Civic Center Station Area Plan Advisory Committee
Wednesday, July 11, 2012; 7:00 – 9:00 p.m.
Volunteer Center, Guide Dogs for the Blind
350 Los Ranchitos Road

**DRAFT CIVIC CENTER STATION AREA PLAN
SUMMARY OF COMMENTS**

The Draft Plan describes the proposed height changes in text but does not contain an exhibit showing the changes. This has caused some confusion, especially in the Redwood Highway Area. Staff recommends that an exhibit be included that clarifies the Committees intent. Following is the current Draft Plan text; information on existing building heights in the area; 3 alternatives on the Redwood Highway Area; and a base map for sketching other alternatives.

Civic Center Drive Bus Drop Area

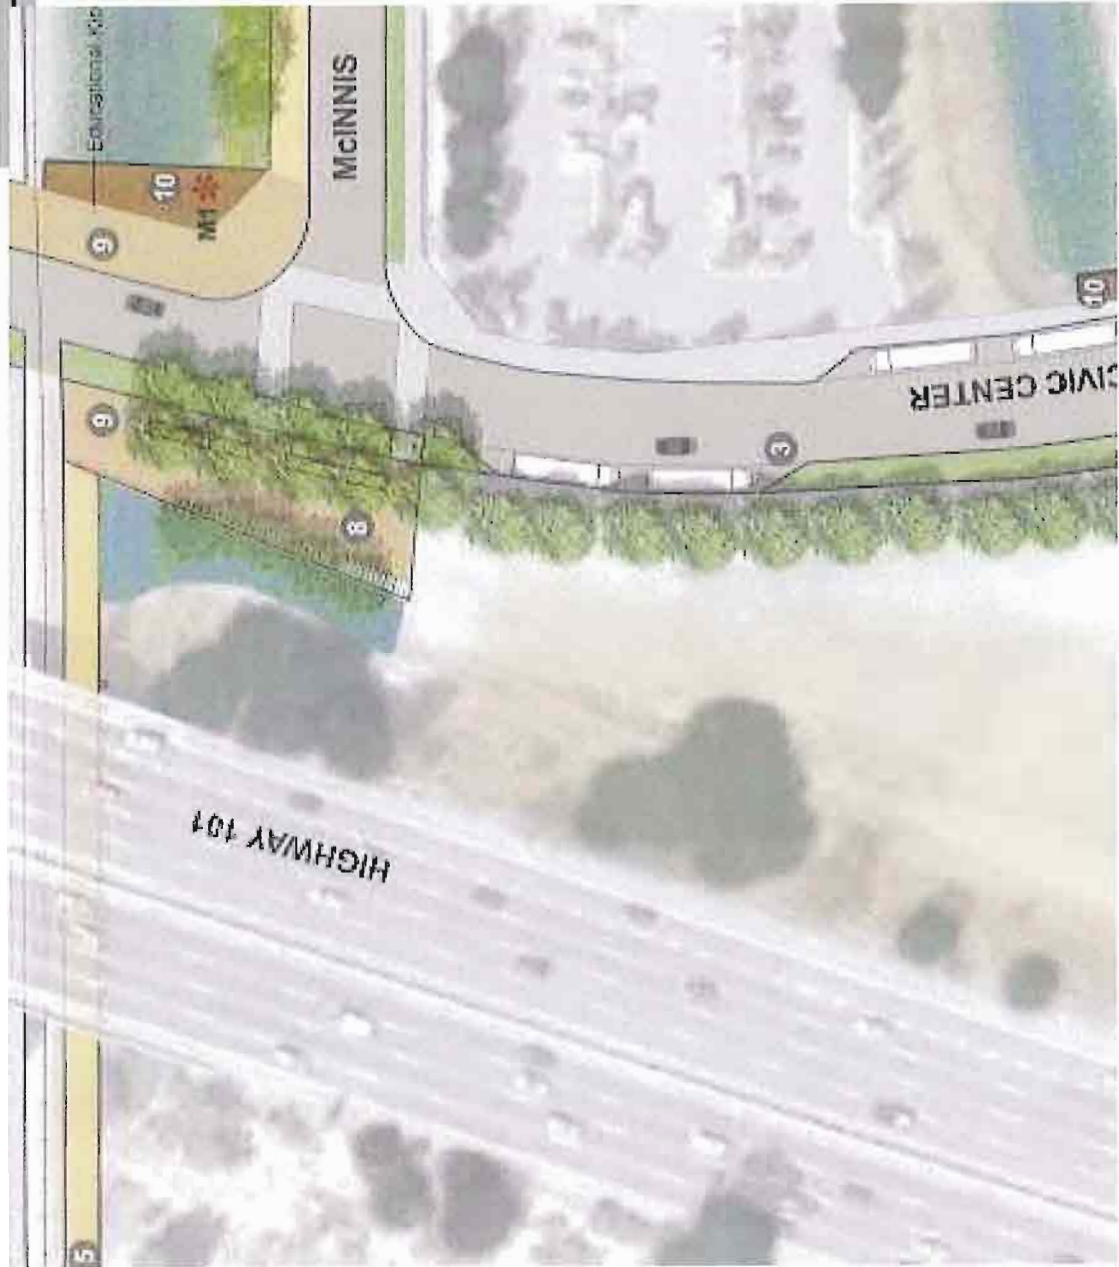
- 1) On Figure 8, the unincorporated section of Los Ranchitos Road, roughly from Glenside Way to Walter Place, is shown with proposed sidewalks on both sides of the road, in addition to a multiuse path that parallels the same stretch of road. The proposed sidewalk improvements are not part of the Marin County Unincorporated

2) On Figure 8, a proposed sidewalk is shown on the north side of Civic Center Drive adjacent to an existing multiuse path near the Lagoon shoreline. Although not on a County maintained road, it is unlikely that a sidewalk would be built adjacent to an existing multiuse path. A connection between Memorial Drive and Civic Center Drive intersection to the multiuse path is a more likely improvement scenario.

4) The existing pathway improvements along Pilgrim Way are not shown on Figure 8.

5) Figure 8 indicates a sidewalk along the freeway between Merrydale Avenue Overcrossing and the relatively high speed US 101 off ramp (with no stop control at the proposed pedestrian crossing). Although not in our jurisdiction, this scenario seems very unlikely and we would encourage contacting City of San Rafael Public Works to discuss.

much as possible (SMNA)	access.
40	Sidewalks Los Ranchitos	<ul style="list-style-type: none"> On Figure 8, the unincorporated section of Los Ranchitos Road, roughly from Glenside Way to Walter Place, is shown with proposed sidewalks on both sides of the road, in addition to a multiuse path that parallels the same stretch of road. The proposed sidewalk improvements are not part of the Marin County Unincorporated Area Bicycle and Pedestrian Master Plan. In addition, the adjacent multi-use path would be able to serve pedestrians in the area. We recommend removing the proposed sidewalk along Los Ranchitos and showing connections to the multiuse path at North San Pedro Rd., Walter Place and the northern end of Circle Drive (where there is existing stop control intersection and transit stop). (County of Marin Letter) 	<p>Accessing the multi-use path will not be difficult from the road, as the path would be right up against the road along this segment and installing sidewalks may involve the removal of some trees.</p> <p>Suggest: Delete recommendation for sidewalks on this section, note in the text why none are recommended and amend Figure 8.</p>

41	Sidewalks Civic Center Drive	<ul style="list-style-type: none"> On Figure 8, a proposed sidewalk is shown on the north side of Civic Center Drive adjacent to an existing multiuse path near the Lagoon shoreline. Although not on a County maintained road, it is unlikely that a sidewalk would be built adjacent to an existing multiuse path. A connection between Memorial Drive and Civic Center Drive intersection to the multiuse path is a more likely improvement scenario. (County of Marin Letter) 	<p>Accessing the multi-use path around the Lagoon is difficult to access from Civic Center Drive. No change proposed.</p>
42	Sidewalks Peter Behr Drive	<ul style="list-style-type: none"> Because of the limited internal circulation patterns it is unlikely that sidewalks would be built on both sides of Peter Behr Drive between Civic Center Drive and Vera Schultz Dr. More than likely any sidewalk constructed would be along the Christmas Tree / General Services Building side of the road only (County of Marin Letter) 	<p>The recommendation for sidewalks on both sides of the street between Civic Center and Vera Schultz Drive merely closes gaps in the existing network. It would not preclude the solution suggested. No change proposed.</p>

43	Sidewalks Pilgrim Way	<ul style="list-style-type: none"> The existing pathway improvements along Pilgrim Way are not shown on Figure 8. (County of Marin Letter) 	<p>Suggest: Amend Figure 8 to show improvements.</p>
44	Sidewalks Merrydale	<ul style="list-style-type: none"> Figure 8 indicates a sidewalk along the freeway between Merrydale Avenue Overcrossing and the relatively high speed of US 101 off ramp (with no stop control at the proposed pedestrian crossing). Although not in our jurisdiction, this scenario seems very unlikely and we would encourage contacting City of San Rafael Public Works to discuss. (County of Marin Letter) 	<p>This is an older version of the figure. This was corrected in the Public Draft.</p>
45	Pedestrian only crossing at Walter Place and west of	<ul style="list-style-type: none"> Footpath at Corrillo/Walter Place – continue pedestrians ability to cross tracks (SRMIA) Explicitly state no vehicle crossing at Merrydale or Walter Place; peds and bikes only (SRMIA) 	<p>Suggest: pg.28 – Add sentence to the end of section on Walter Place: <i>Maintain the Walter Place crossing of the tracks as pedestrian and bicycles only, with no auto traffic.</i></p>
